# UNITED STATES PATENT AND TRADEMARK OFFICE

APPLICATION NO.	FILING DATE	FIRST NAMED INVENTOR	ATTORNEY DOCKET NO.	CONFIRMATION NO.
10/715,670	11/17/2003	Chiahua Ho	MXICP017	4806

<b>Office Action Summary</b>	<b>Application No.</b> 10/715,670	<b>Applicant(s)</b> HO, CHIAHUA	
	<b>Examiner</b> TRONG PHAN	<b>Art Unit</b> 2827

## DETAILED ACTION

FIG. 4B

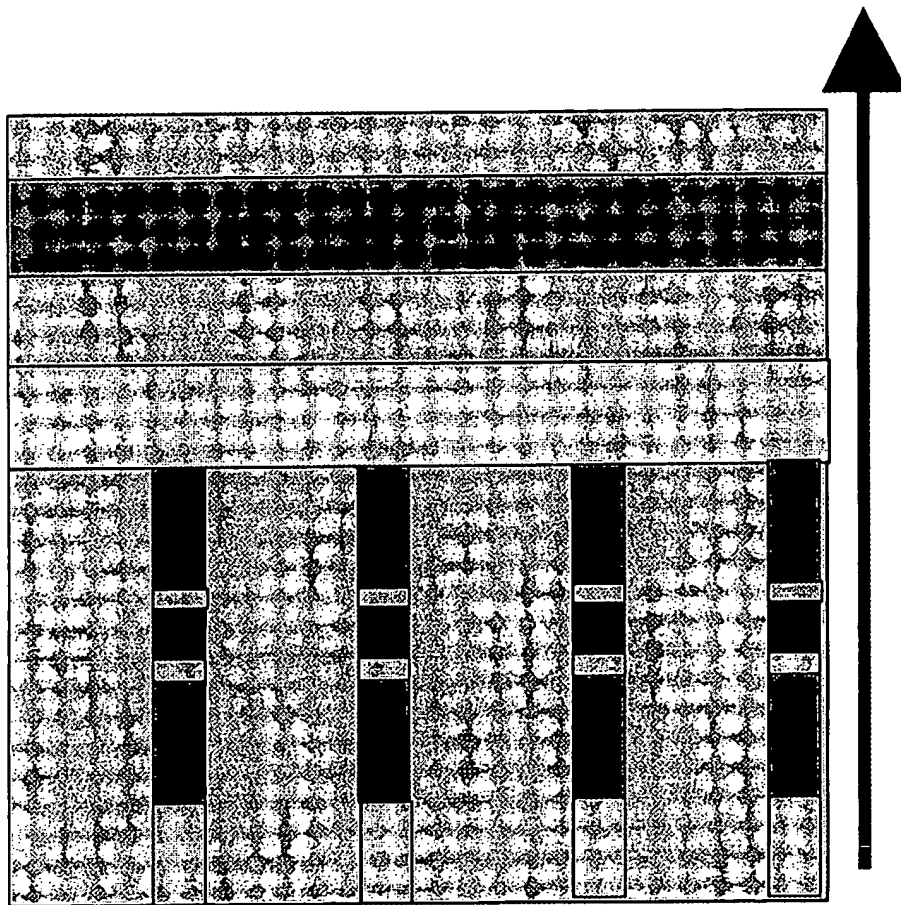
1. The drawings are objected to under 37 CFR 1.83(a). The drawings must show every feature of the invention specified in the claims. Therefore, the features as recited in claims 5-7 and 18-20 (it should be noted that Figs. 4A-B and 5 of the present invention only show the plurality of MTJ devices } each connected to the respective bit line B and word line W via u-metal without any communication with a diode as recited in claims 3 and 17); the magnetic random access memory (MRAM) cell having a magnetic junction tunnel (MTJ) device with a perpendicular magnetic orientation, the first magnetization as recited in claims 8 and 10, the second magnetization as recited in claims 9 and 11, the first-in plane component and the second-in plane component as recited in claim 13 and the first-in plane component cancels out the second-in plane component as recited in claim 14 (it should be noted that Figs. 4A-B and 5 of the present invention show the magnetic random access memory (MRAM) cell 100' represented by the O ring symbol which is totally separated with the MTJ devices) must be shown or the feature(s) canceled from the claim(s). No new matter should be entered.

Claims 5-14 and 18-20 are not vague and indefinite since they are not readable on the respective drawings of the present invention. Because Figs. 4A-B and 5 of the

present invention show the magnetic random access memory (MRAM) cell 100' represented by the O ring symbol which is totally separated with the MTJ devices.
